Widening of SR 107 From I-75 To SR 11/US129

Value Engineering Study Report

August 2009

Re: Widening of SR 107 from I-75 to SR 11/US 129
Project No. STP-0000-00(311), P.I. No. 0000311
Project No. STP-0000-00(314), P.I. No. 0000314
Project No. STP-0000-00(313), P.I. No. 0000313
Value Engineering Study Report

PROVIDE A ONE-MILE PASSING LANE
IN EACH DIRECTION

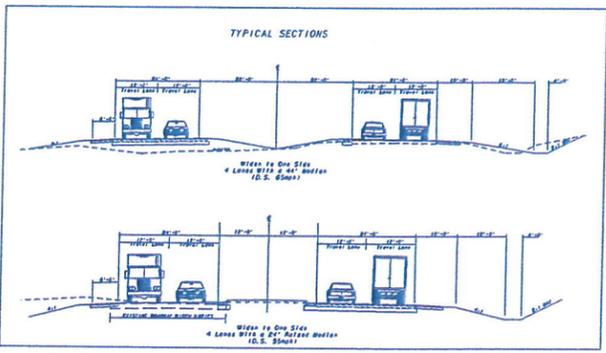
Retain the existing two-lane highway and provide one, one-mile passing lane in each direction between Sta. 300+00 and Sta. 400+00 for westbound traffic and between Sta. 300+00 and Sta. 400+00 for eastbound traffic. Realign SR 107 from Sta. 228+30 to Sta. 278+30; improve all intersections (see sheet 2 of 3); and reconstruct 34% of the existing two-lane rural section to correct geometric deficiencies.

The Need and Purpose statement for this project states that no improvements are required in this corridor for future traffic or because of accidents. Additionally, design year traffic volumes range from 3,700 ADT at I-75 to 1,750 ADT at CR 250/Waterloo and Rebecca Highway. Providing intermittent passing lanes will allow traffic to pass slower vehicles safely without the expense of providing four lanes for the entire corridor. This alternative includes the realignment of SR 107 from Sta. 228+30 to Sta. 278+30 to correct the geometric deficiencies of the existing roadway and enhance safety.

T-4

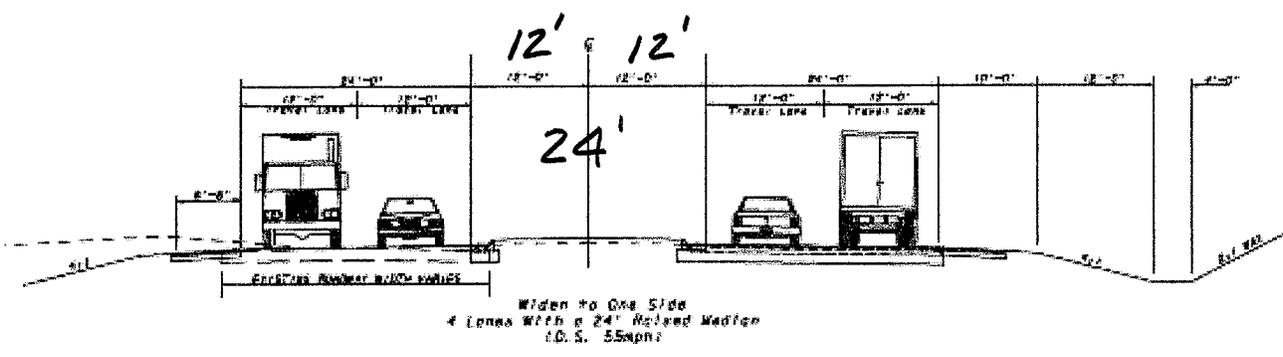
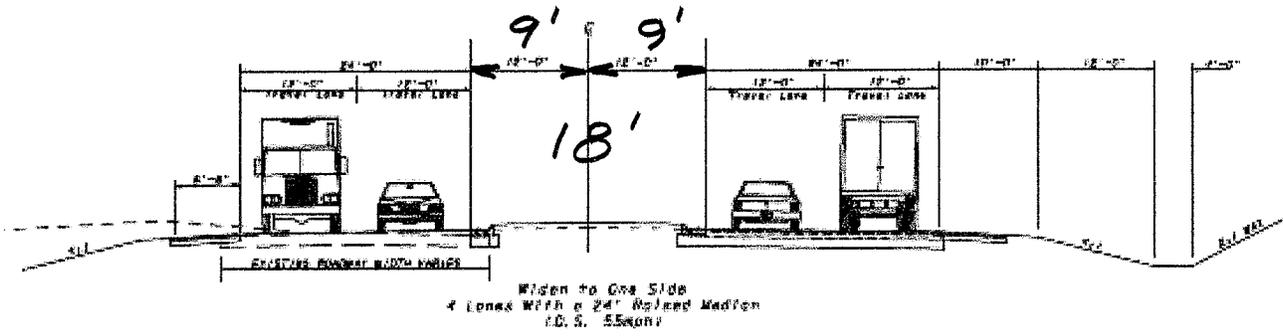
COST SUMMARY	INITIAL COST	PRESENT WORTH RECURRING COSTS	PRESENT WORTH LIFE-CYCLE COST
ORIGINAL DESIGN	\$ 148,310	—	\$ 148,310
ALTERNATIVE	\$ 0	—	\$ 0
SAVINGS	\$ 148,310	—	\$ 148,310

PROJECT: **WIDENING OF SR 107 FROM L 75 TO CR 250**
 STP00-0000-00(311) P.I. Number 0000311

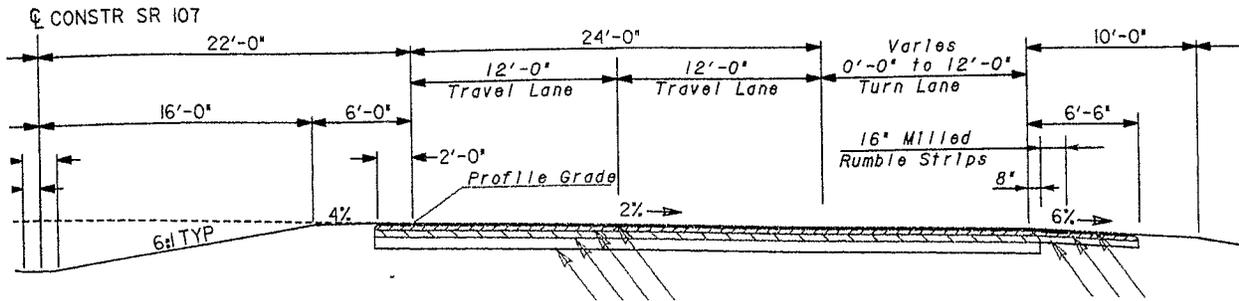
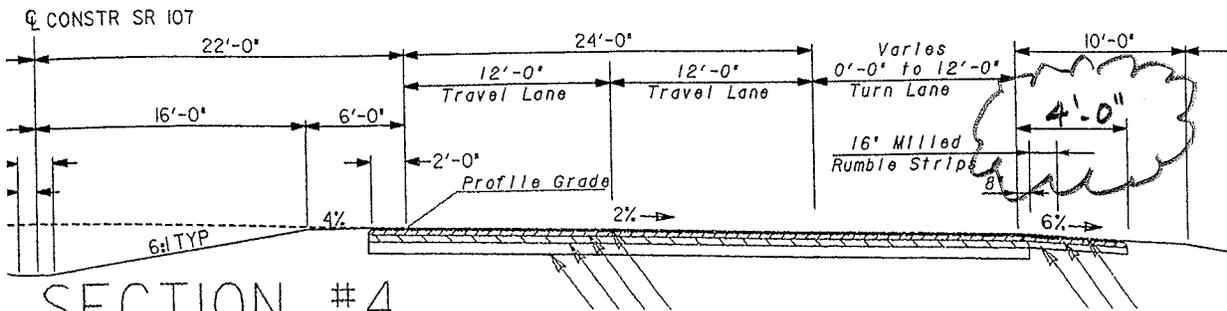
Before consideration was given to bicycles, outside shoulders typically had 4 ft of pavement. Since there is not a bicycle route at this location, there is no reason to provide 6 ft 6 in of pavement.

TYPICAL SECTIONS

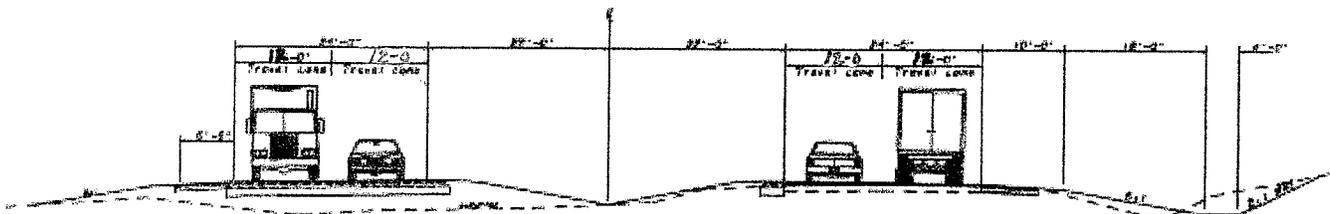
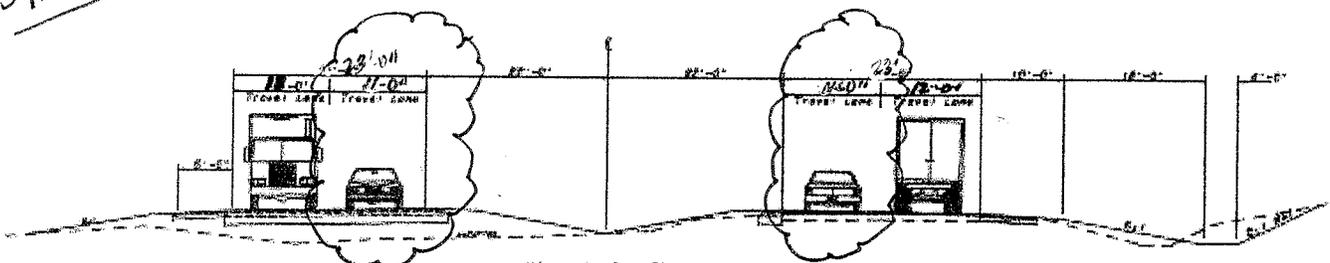
Downtown Atlanta has 11-ft-wide lanes on its freeways without any significant problems. Design year traffic volumes along SR 107 from I-75 to CR 250 range from 3,700 ADT at I-75 to 1,750 ADT at CR 250. Constructing 11-ft-wide inside lanes on SR 107 from I-75 to CR 250 will save material and construction cost without sacrificing the quality of traffic movement. Keeping 12-ft-wide outside lanes will provide enhanced goods movement for 30 percent truck traffic traveling through the corridor.

2/4
Alt. G-1

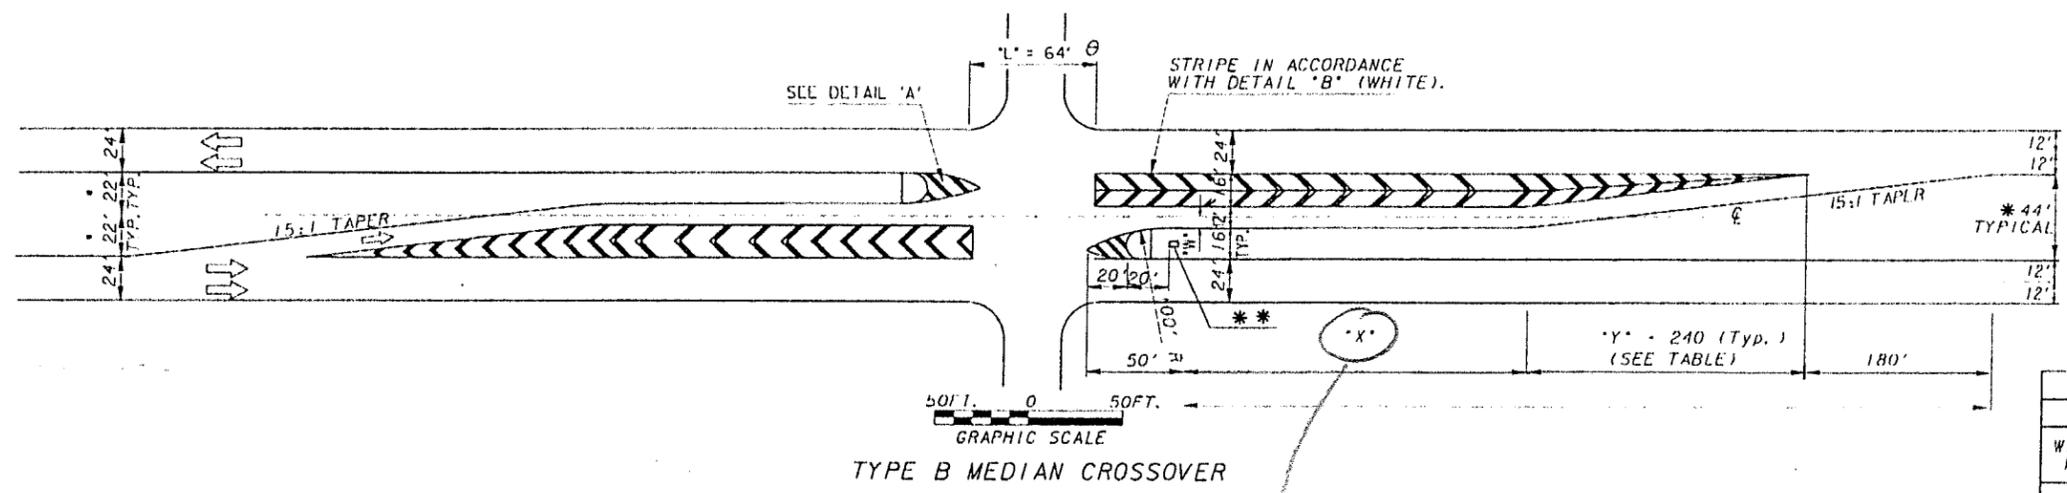
The original design uses the maximum “x” length of 450 ft for storage and deceleration for left-turn lanes per GA. Construction Detail M-3.

Use the minimum “x” length of 300 ft for storage and deceleration for left-turn lanes per GA. Construction Detail M-3.

PROJECT: **WIDENING OF SR 107 FROM I 75 TO CR 250**
 STP00-0000-00(311) P.I. Number 0000311

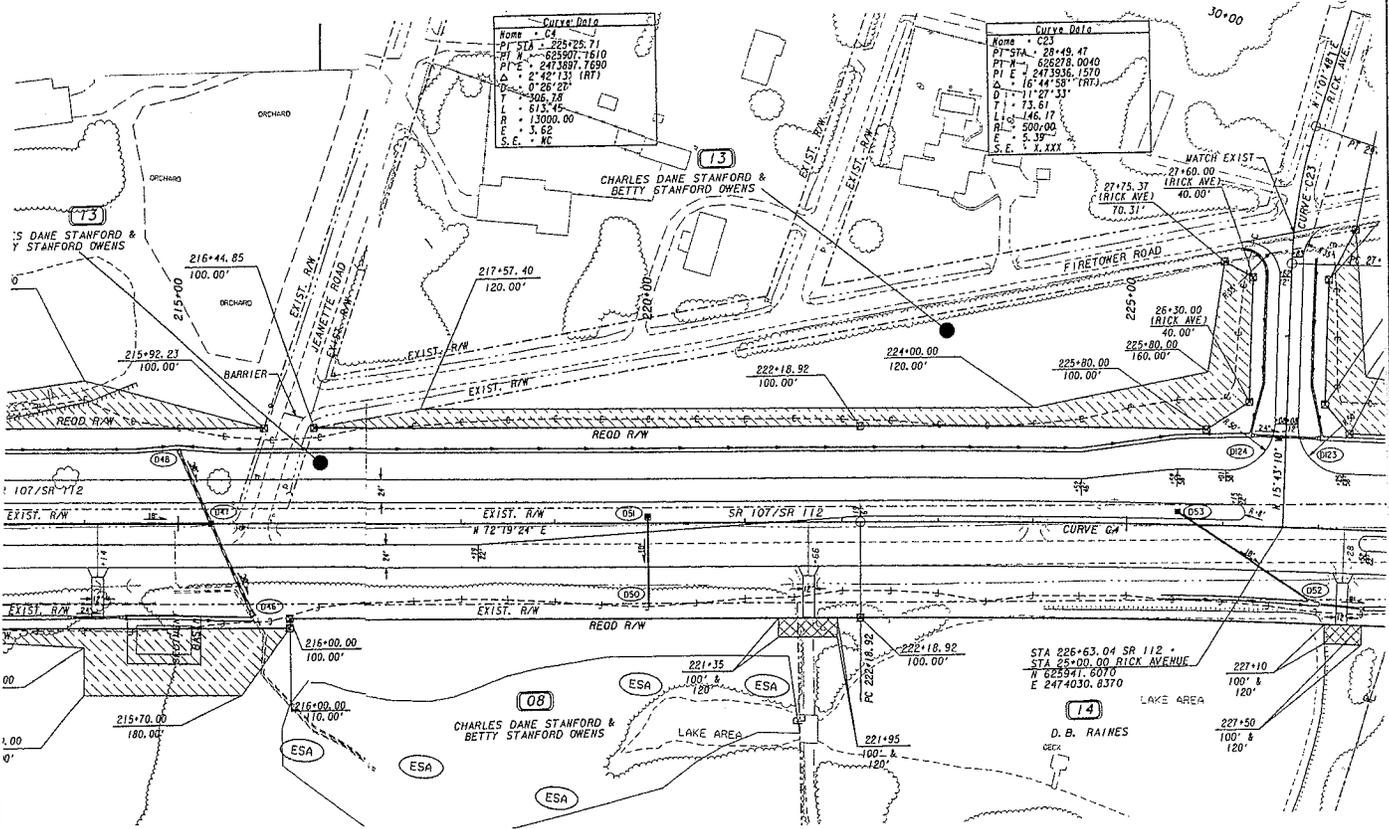
The original design provides a new connector road approximately 300 ft long to connect Firetower Road to SR 107 at Rick Road. Minor improvements can be made at the existing intersection at Jeanette Road to provide access at the current location. The median opening would be moved back to the intersection at Jeanette Road, resulting in a longer drive for some residents on the south side of SR 107 to get to a median opening.

G-5

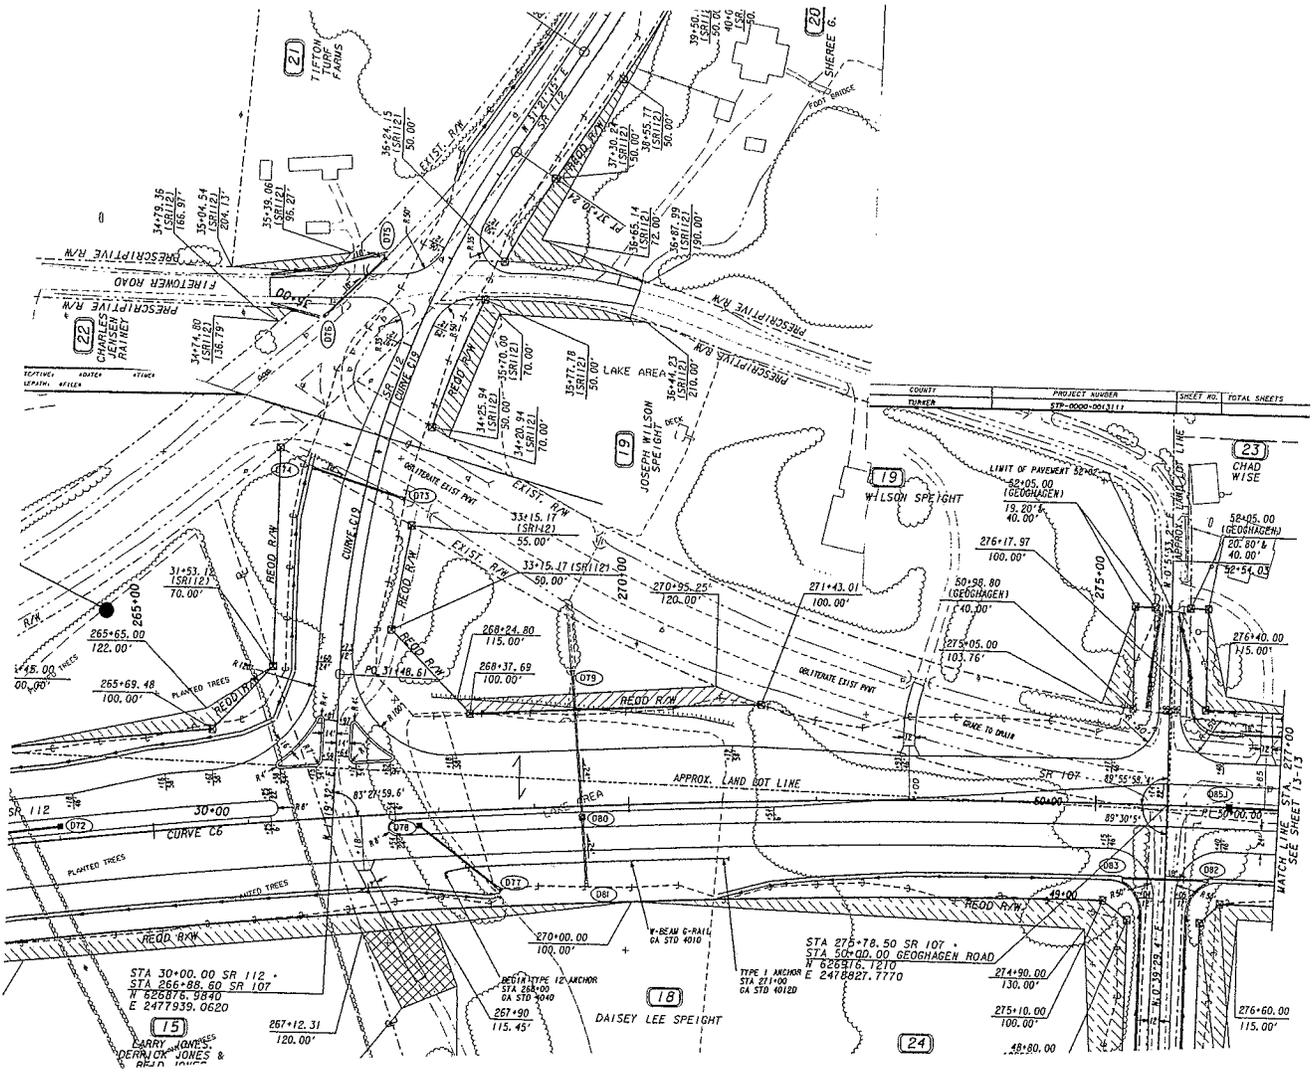
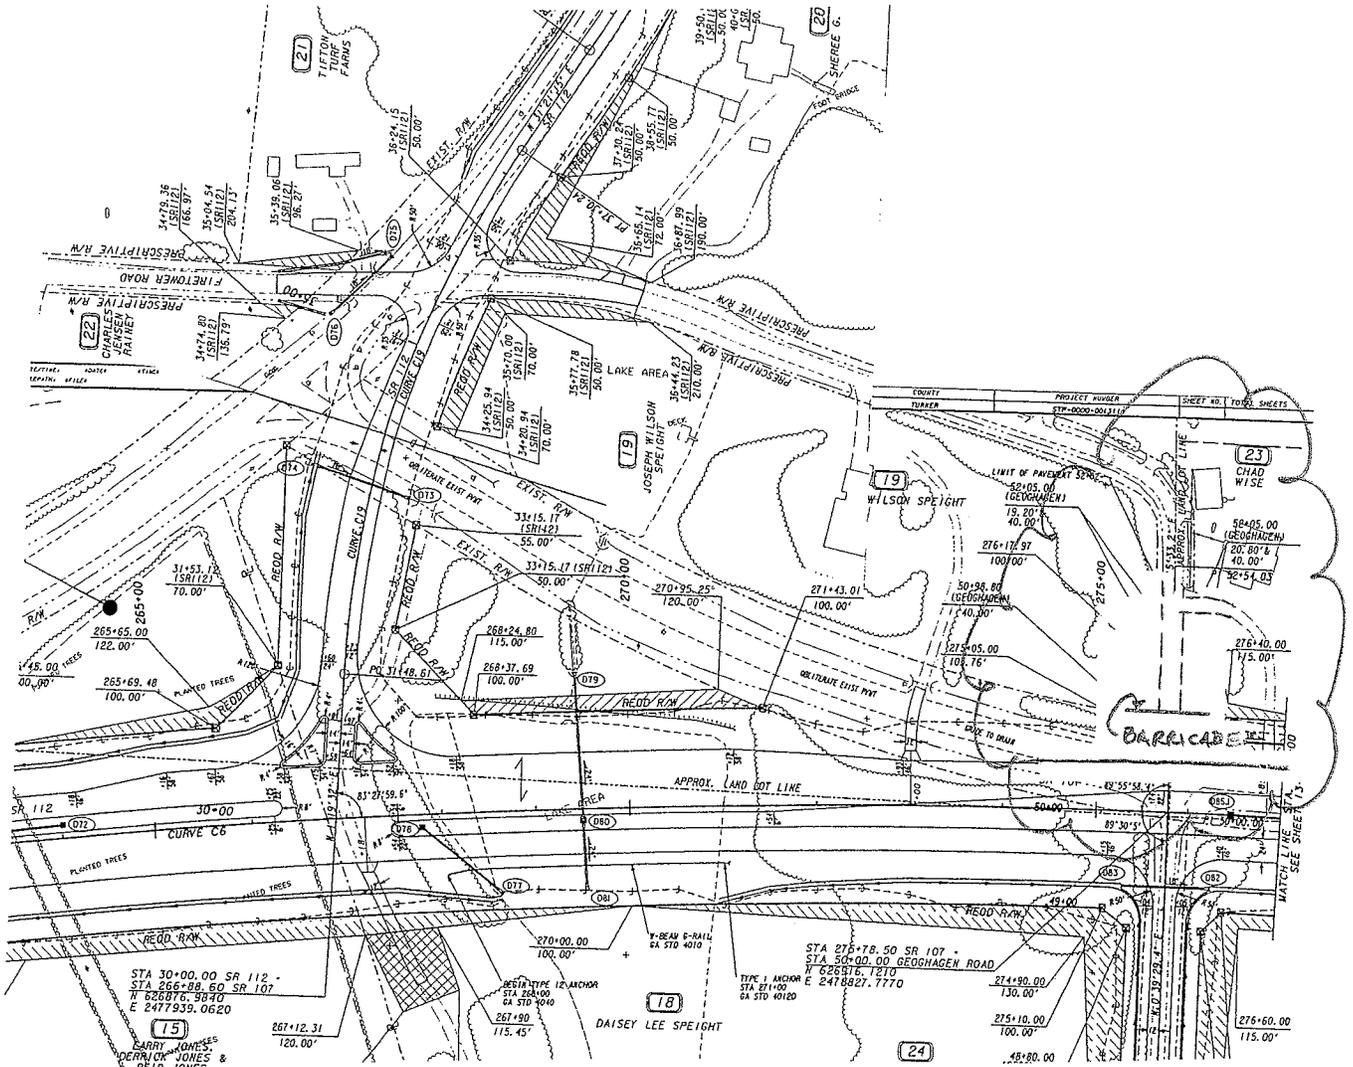
The design year ADT on Geoghagen Road is 100. Geoghagen Road will connect to SR 112 on the north side of SR 107 after construction is complete. There will not be a median opening at Geoghagen Road on SR 107. The residence nearest to SR 107 will continue to have access to SR 107 via a driveway. There is no reason to maintain direct access to SR 107 from Geoghagen Road.

ALTERNATIVE NO.: **T-1**

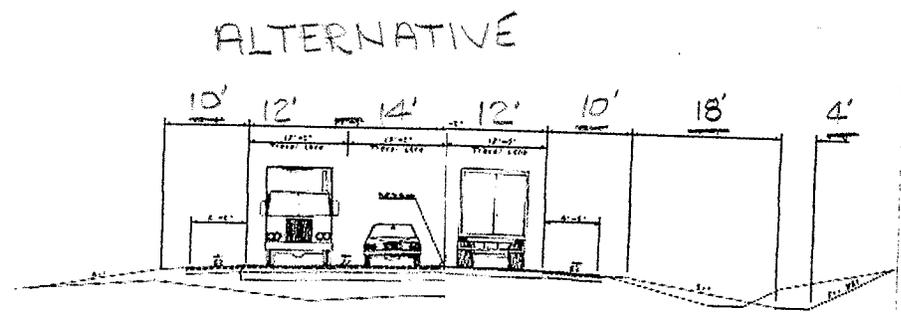
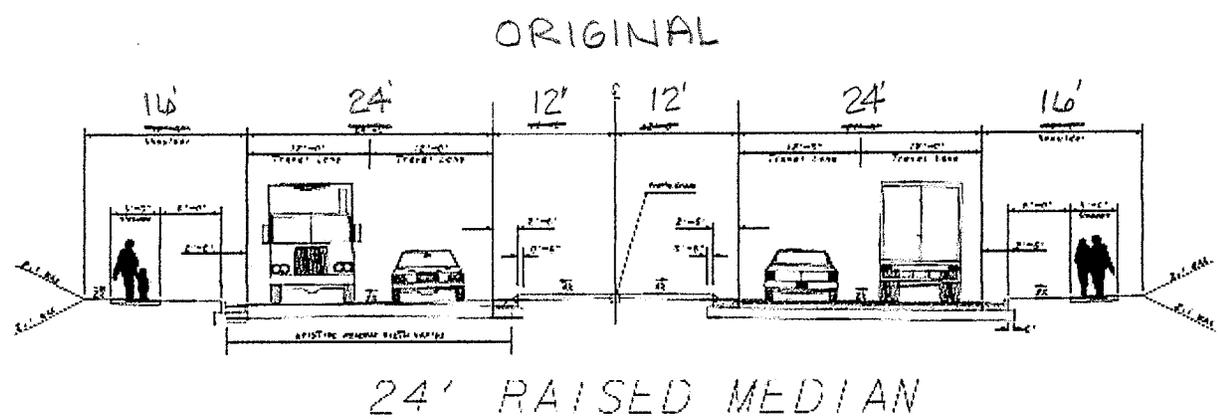
A three-lane rural section with a center turn lane will correct geometric deficiencies and promote economic development at a significantly reduced cost. Design year traffic volumes along SR 107 range from 3,650 ADT at Sta. 490 to 10,950 ADT at SR 11/US 129.

T-4

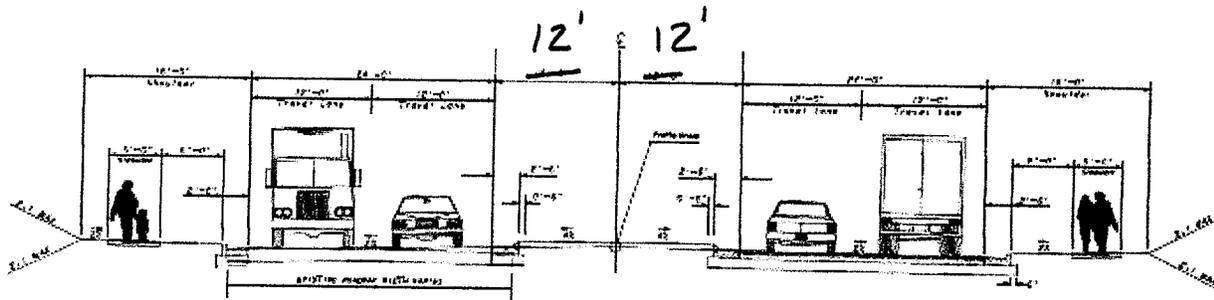
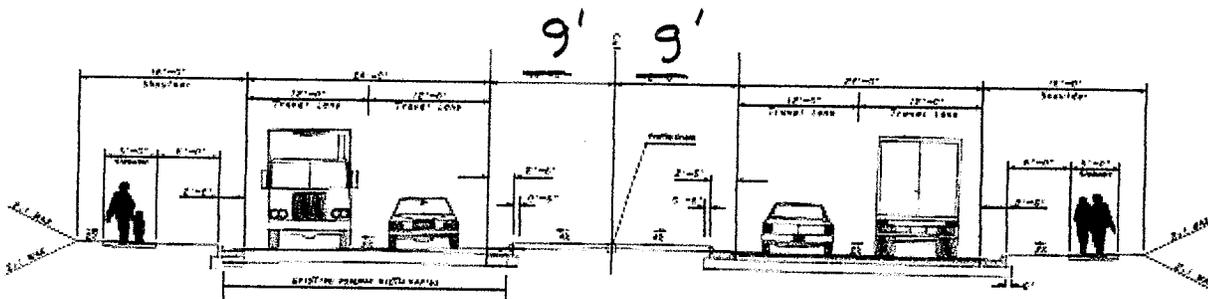
COST SUMMARY	INITIAL COST	PRESENT WORTH RECURRING COSTS	PRESENT WORTH LIFE-CYCLE COST
ORIGINAL DESIGN	\$ 160,657	—	\$ 160,657
ALTERNATIVE	\$ 0	—	\$ 0
SAVINGS	\$ 160,657	—	\$ 160,657

ALTERNATIVE NO.: T-5

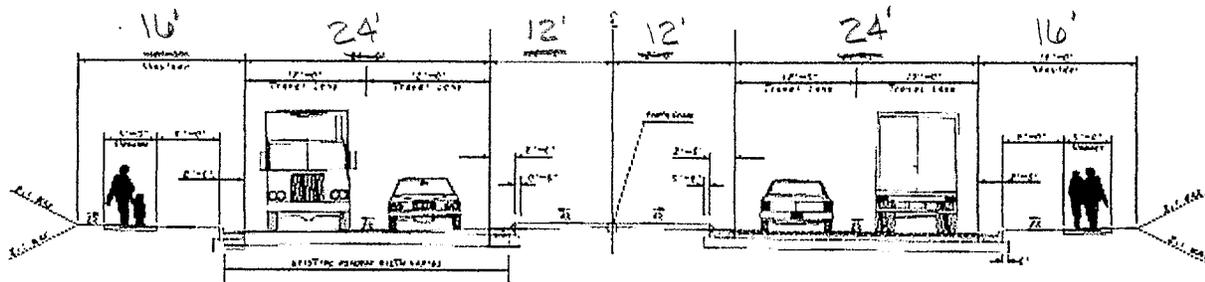
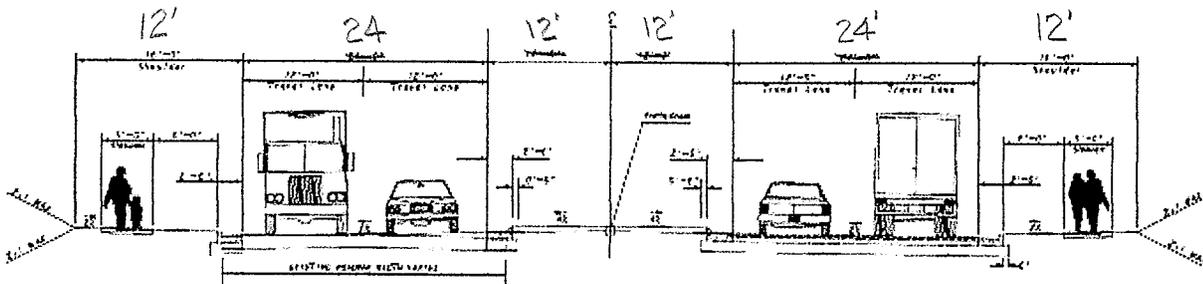
Reducing the urban shoulders from 16-ft-wide to 12-ft-wide will reduce excavation costs, grassing requirements and right-of-way requirements with no significant reduction in functionality.
